Response to Kirklees comments ref WK/202502038 and email from NH dated 31 January 2025

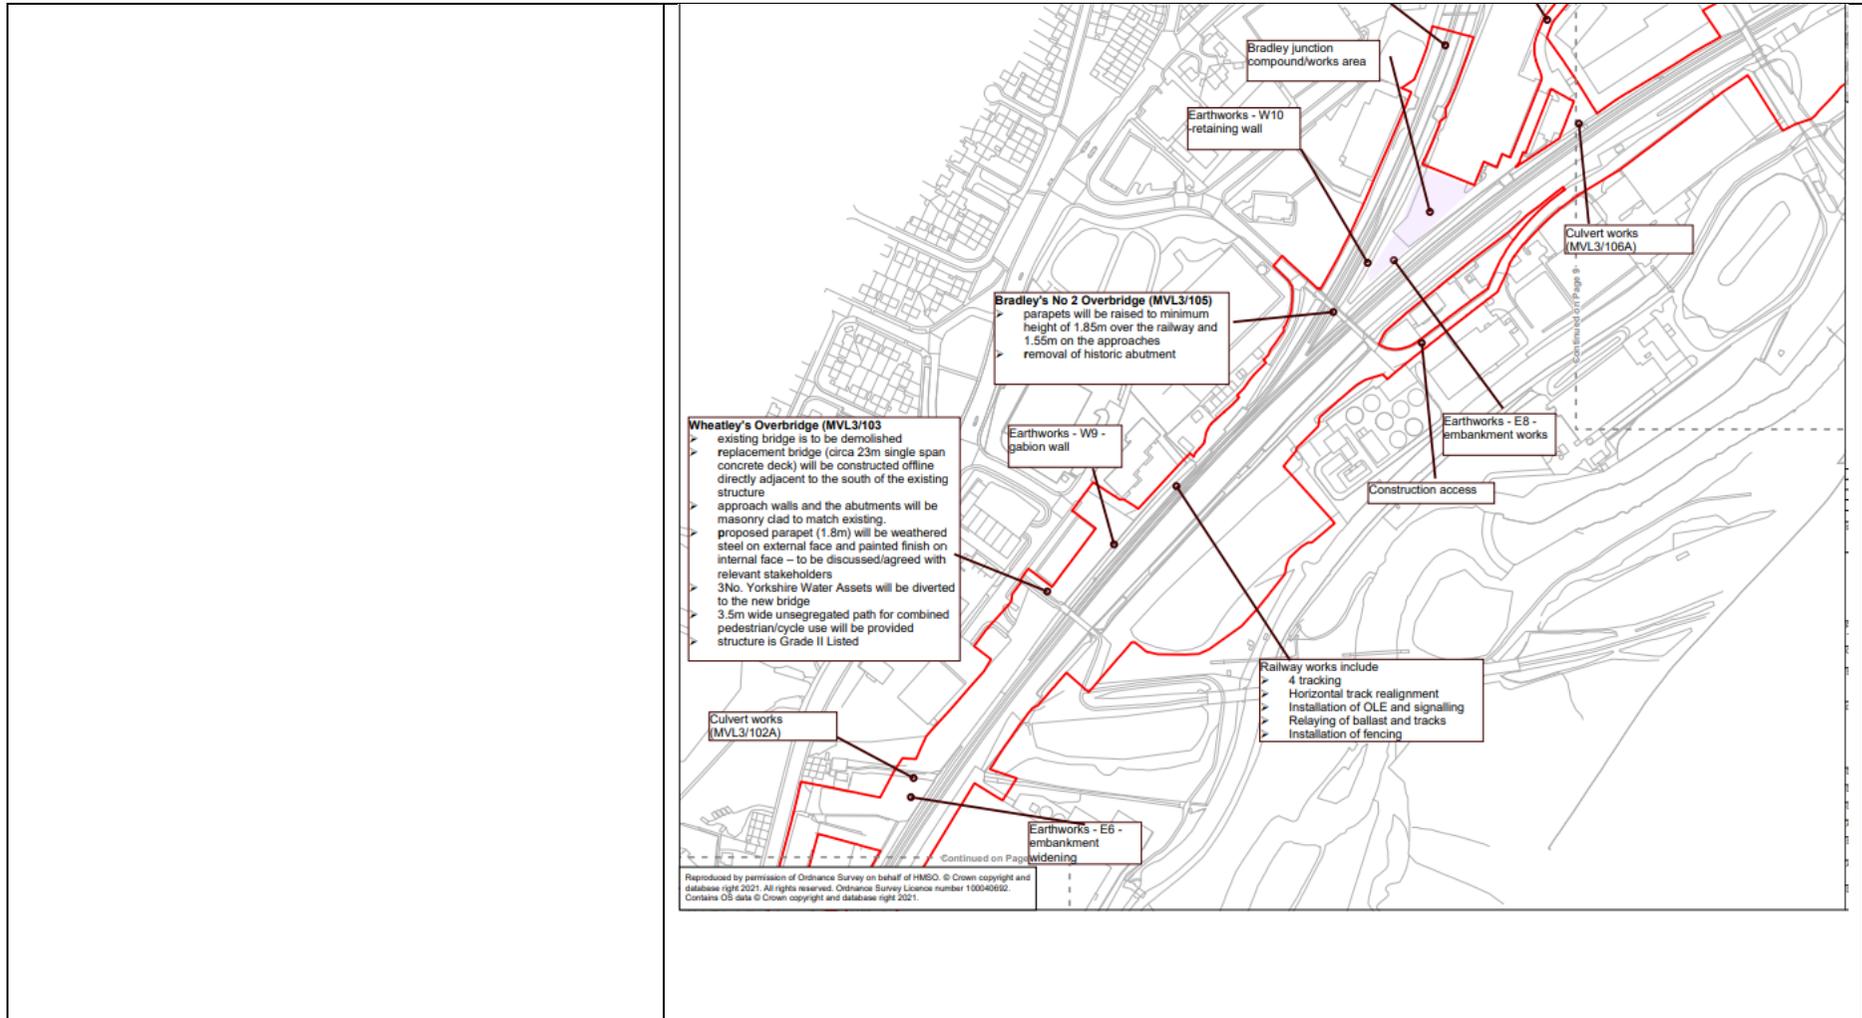
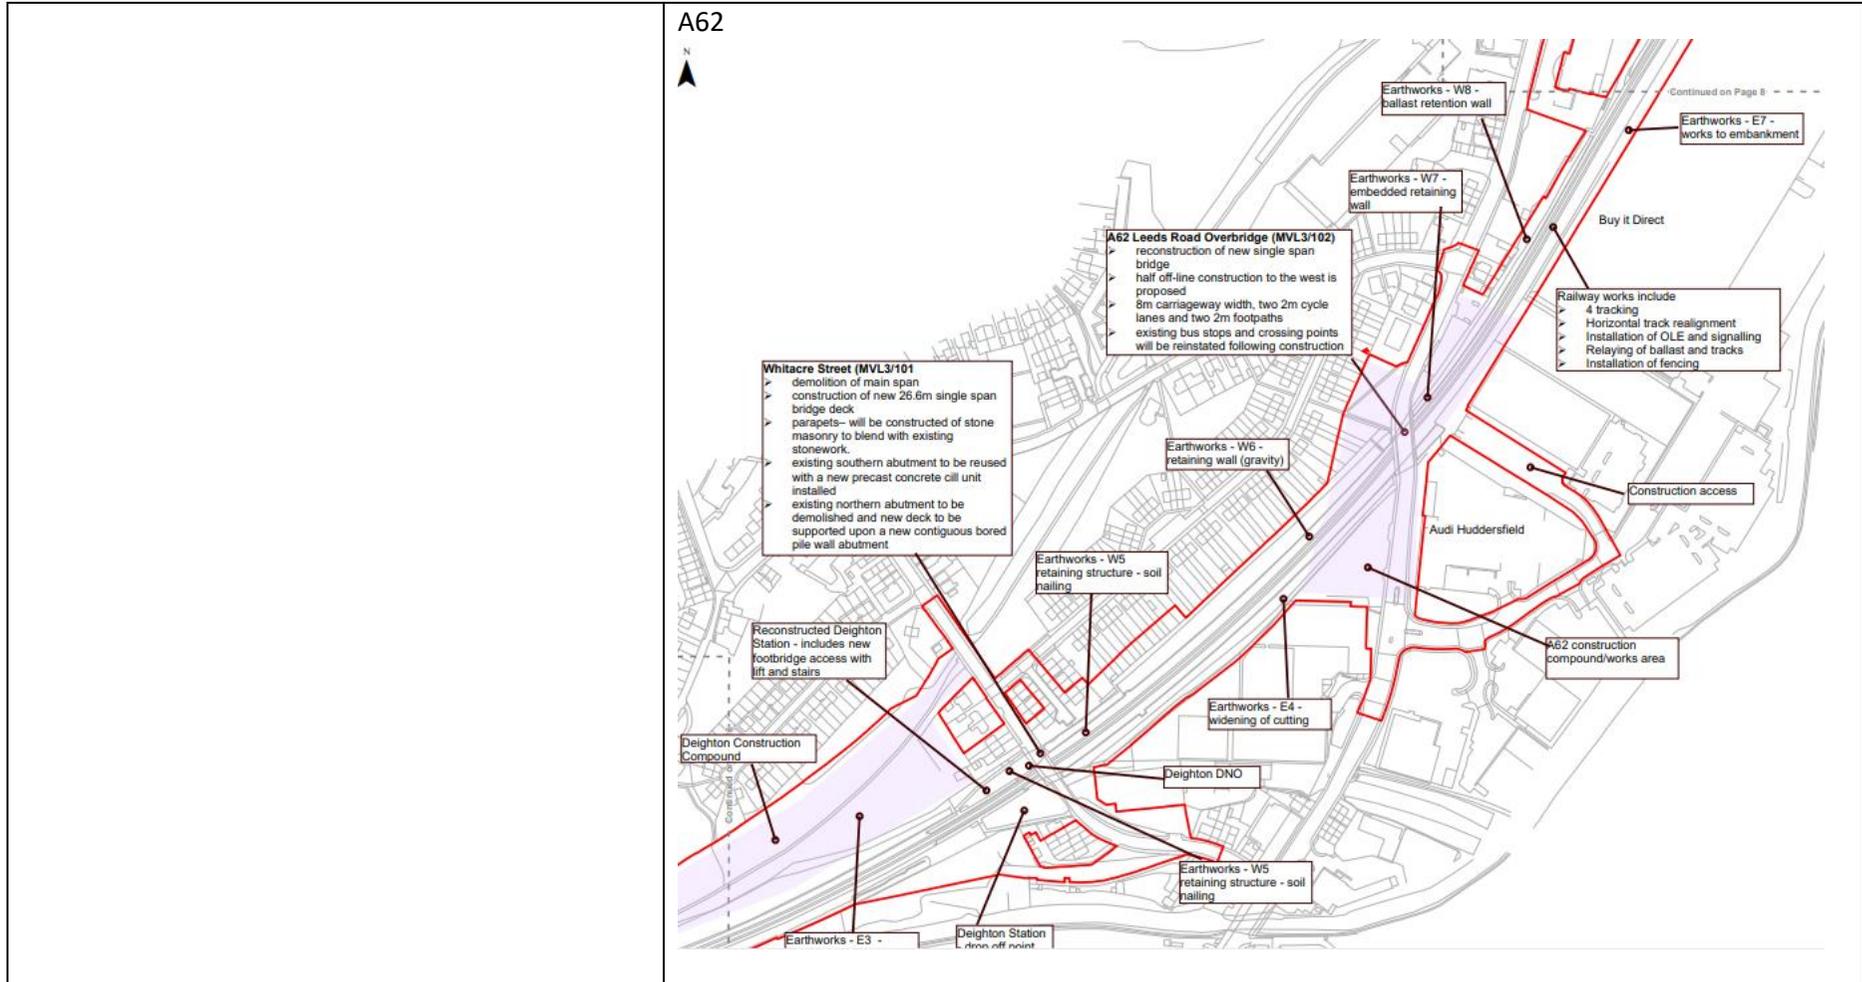
<p>A pick up point will be provided at the A62 compound and also on the A62 close to the site to shuttle any pedestrians into the work site. Provision will also be made to pick up cyclists at the A62 compound location (cycles will be parked at the A62 compound). The applicant considers that the proposed access arrangements are sufficient given the low level of staffing on the site and provide the safest option due to the constrained site entrance.</p> <p>The applicant does not consider there to be a requirement for a separate pedestrian/cycle route entrance point.</p>
<p>How/where are the assembled bridge sections to be transported to?</p>	<p>The site will service bridge deck assembly for works at MVL3/103 Wheatley's Overbridge and MVL3/102A A62 overbridge – see below.</p>

<p>Bridge decks will be manoeuvred into position using Self Propelled Modular Transporters (SPMTs). Movement of these loads on the highway and any traffic management requirements will be discussed and agreed with the Local Highways Authority Team via the ongoing discussions between the TRU Alliance Site team and Kirklees Council Highways Officers.</p>
--	---
